## ***Interactive comment on “Exploitation of the far-offshore wind energy resource by fleets of energy ships. Part A. Energy ship design and performance” by Aurélien Babarit et al.***

**Aurélien Babarit et al.**

Received and published: 23 April 2020

**Fig. 1.** New Figure 6: Absorbed power (top) and propulsion power to water turbine mechanical power (bottom) as function of the water turbine diameter. The true wind speed is 10 m/s and the true wind angle is 90°

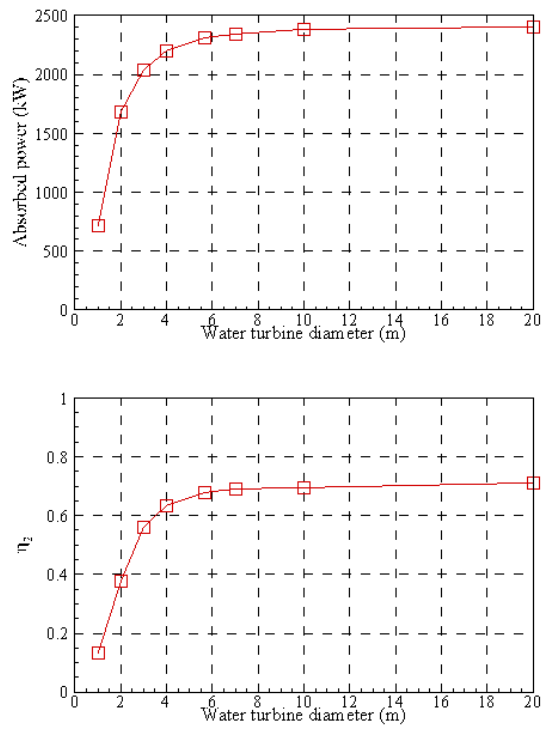
Referee's comment 4 : Eq. 15: This is an interesting result that the efficiency increases for increasing turbine area. This is different from traditional wind turbines where the efficiency (under the same, implicitly made assumptions on the flow) will be constant, and it leads to a different optimum. In particular, it seems that the size of the turbine will not be as limited by the structural cost (as in wind turbines)? The manuscript should explore and discuss these scaling relationships a bit and what can be learned from them.

Answer: Thanks, this is indeed a key difference of energy ships in comparison to wind turbines. In order to address your comment, we've added a figure (Fig. 6 in the revised manuscript) which shows the absorbed power and efficiency as function of the turbine diameter. The following text has also been added in section 2.2:

"Fig. 6 shows an example of the absorbed power and efficiency  $\eta_2$  as function of the water turbine diameter. One can see that, as expected, the efficiency increases with increasing turbine diameter. However, it appears that the rate of increase in efficiency diminishes with increasing turbine diameter, which is worth noting as turbine cost will also increase with increasing diameter. Therefore, despite theory indicates that as large as possible water turbine should be used, turbines of practical dimensions may be used with little efficiency loss."
